**Proposed Development
At
63-71 High Street, Hampton Hill
TW12 1LZ**

JOINT MEMORANDUM

Proposed Drainage Strategy

STATUS		PLANNING	
CLIENT GREAT PLANET LTD			
PROJECT 69-71 HIGH STREET HAMPTON HILL			
DRAWING TITLE DRAINAGE LAYOUT AT BASEMENT FLOOR LEVEL			
DRAWN	EP	DATE	MAY 2016
PROJECT ENGINEER	EP	SCALE	AS SHOWN @ A1
CHECKED	SS	APPROVED	AS SHOWN @ A1
DRAWING NUMBER	SLS0500.002	REVISION	B

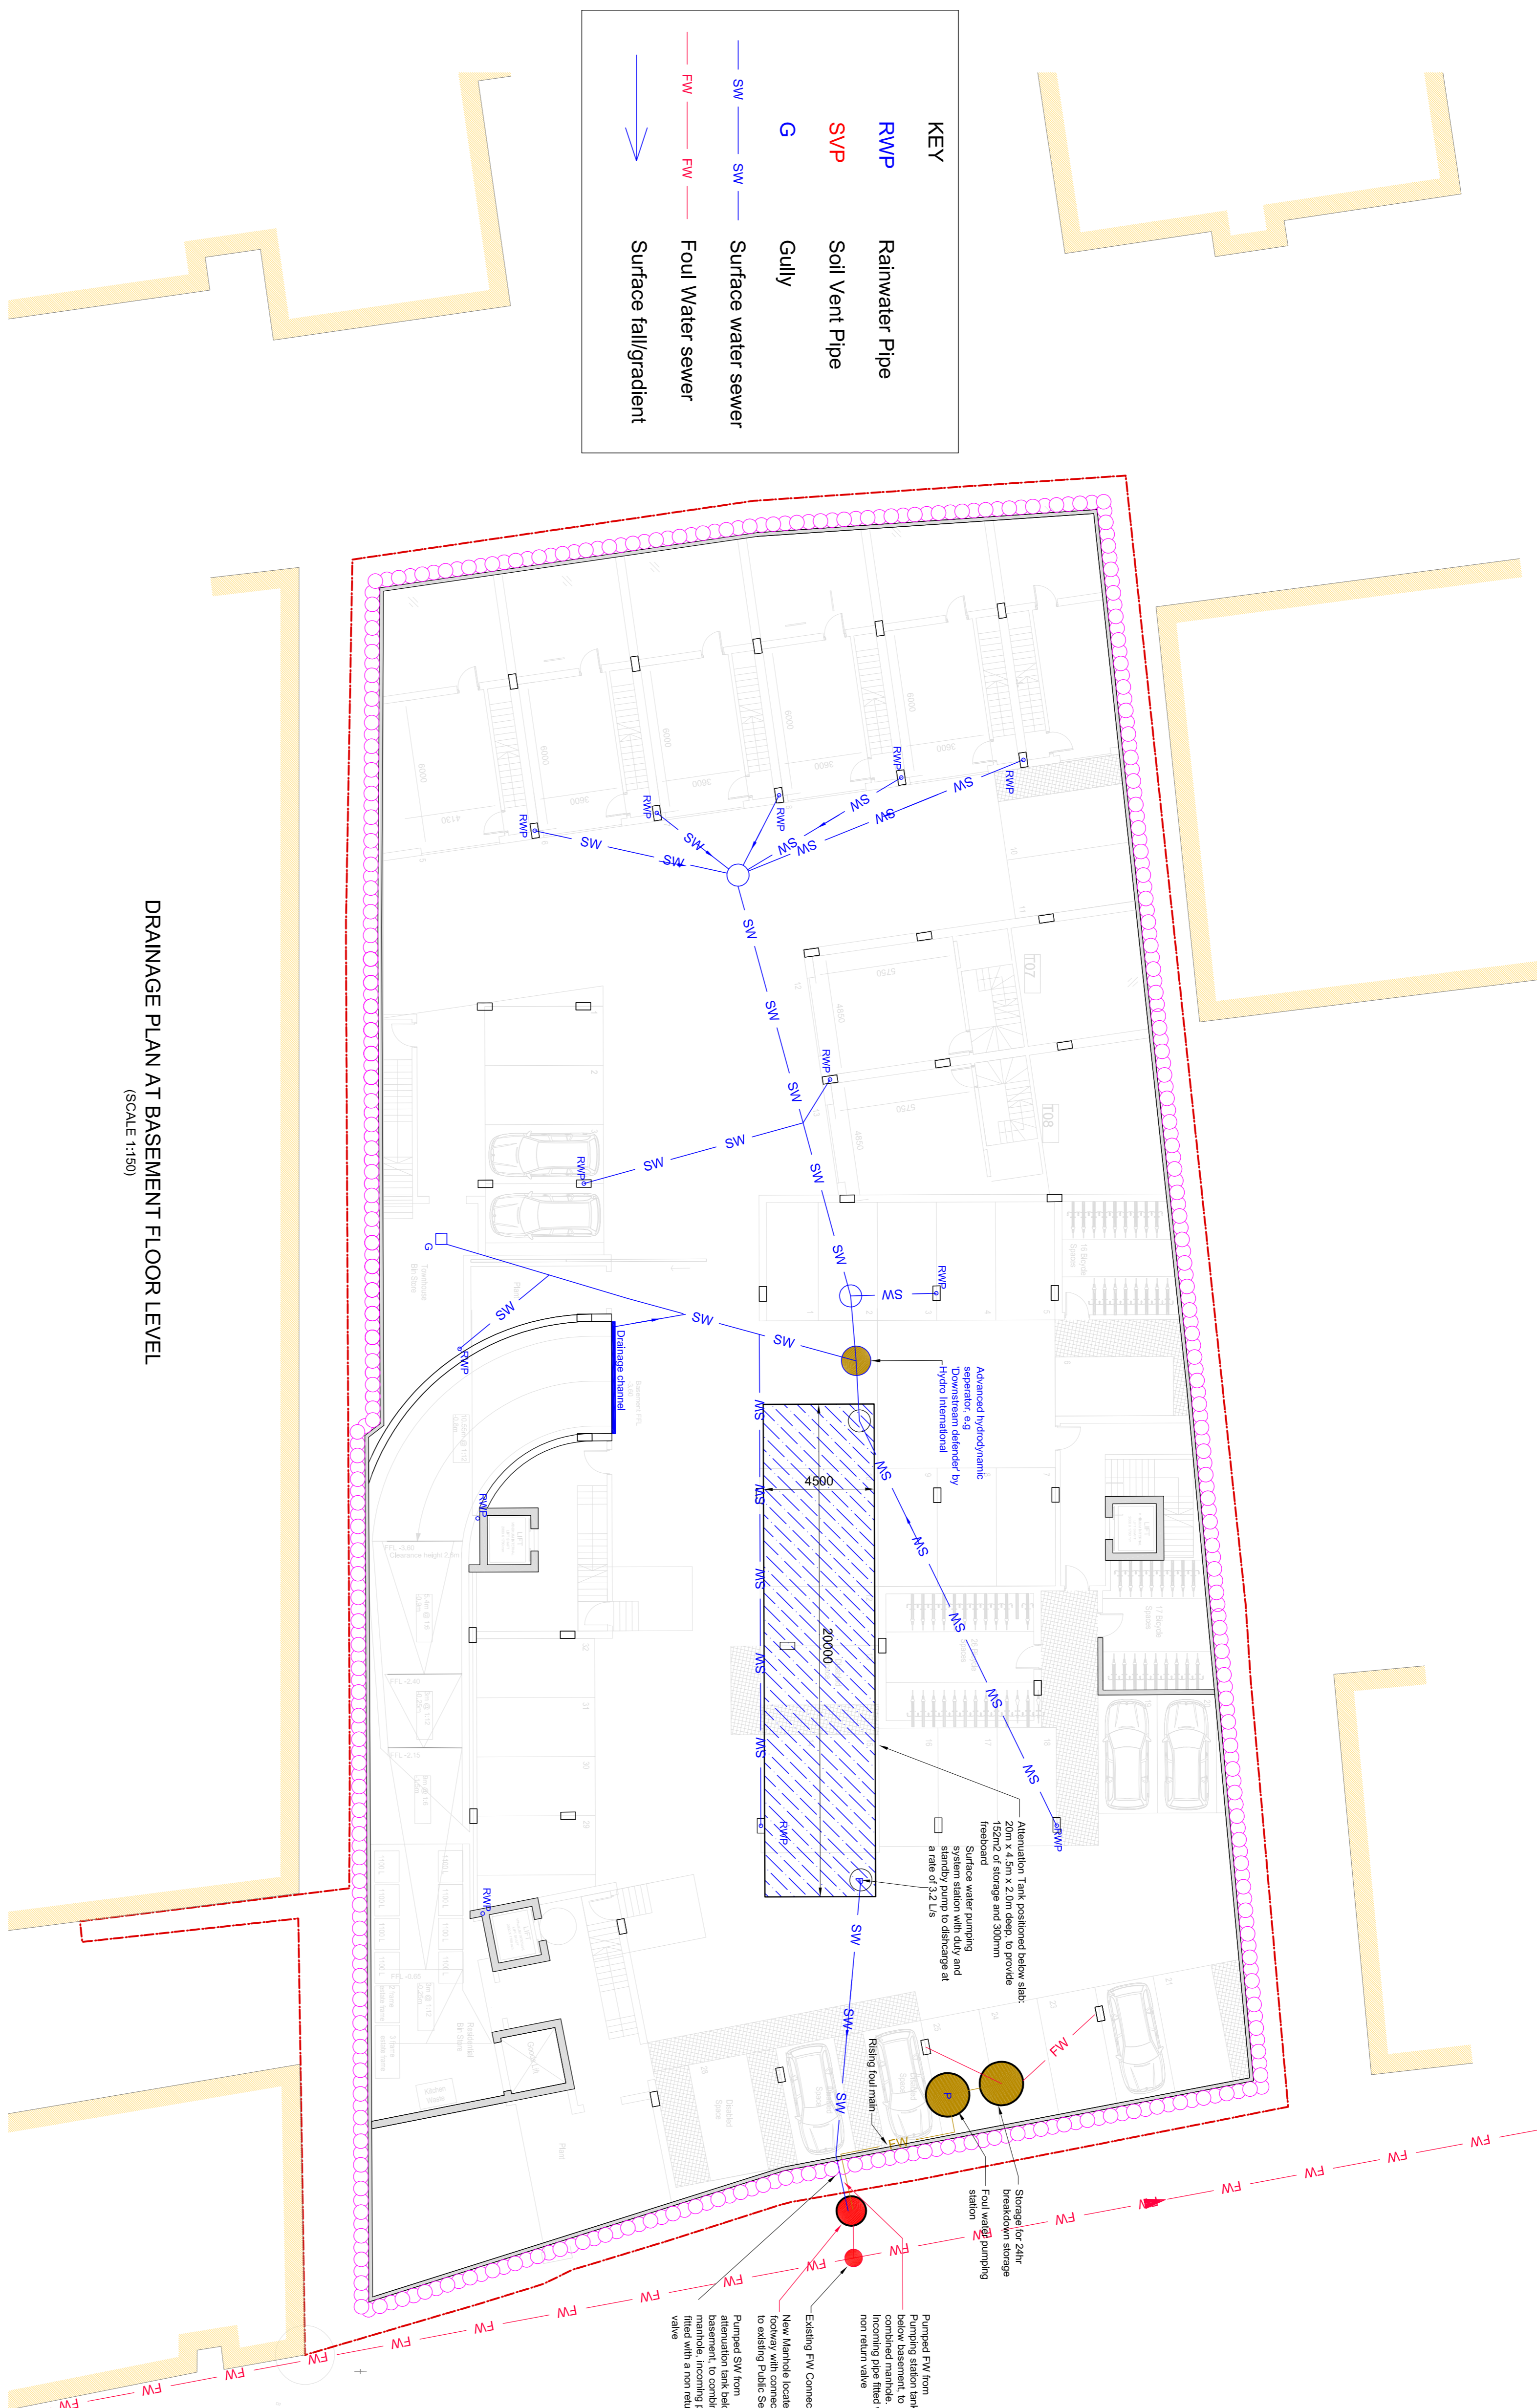
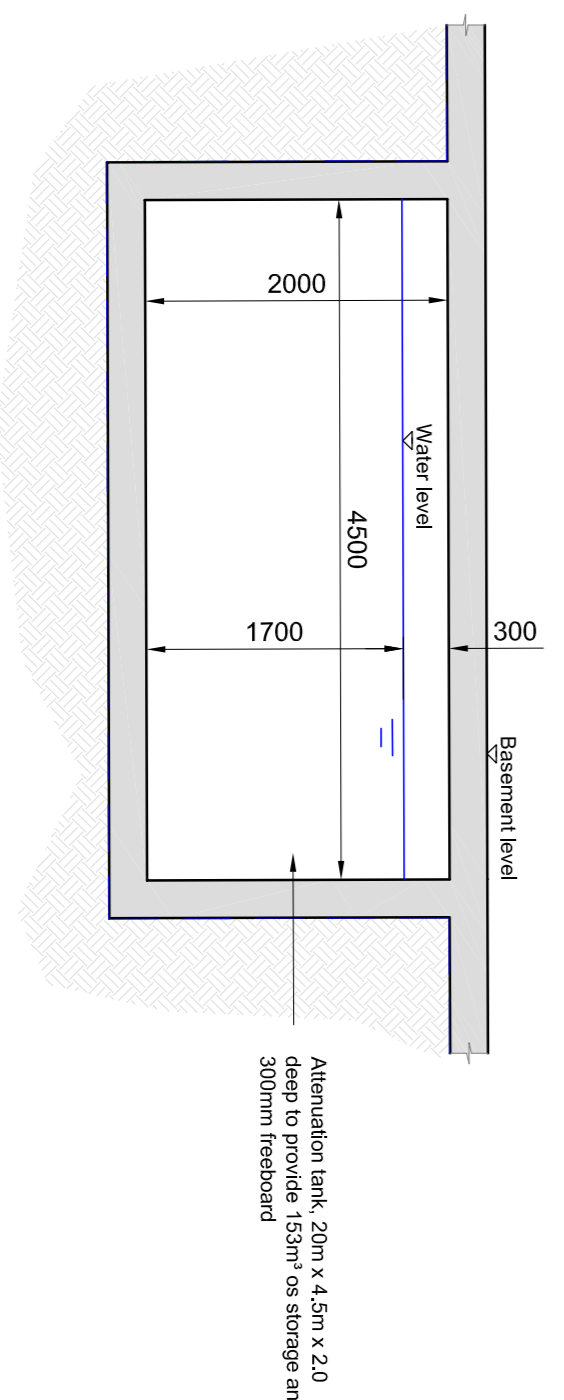
Drawing SL05030.401 (no Revision), included in RAB Consultants' FRA does not show the correct proposed drainage strategy, HBPW LLP Drainage Strategy and proposals shown on drawings SL05030.401 rev B and SL05030.402 rev B included in Appendix 4 of the Drainage Strategy and included again in Appendix 1 of this Memorandum is the correct drainage strategy for the development.

When reading the RAB Consultants FRA; drawing SL05030.401 (no revision) should be replaced with drawings SL05030.401 rev B and SL05030.402 rev B.
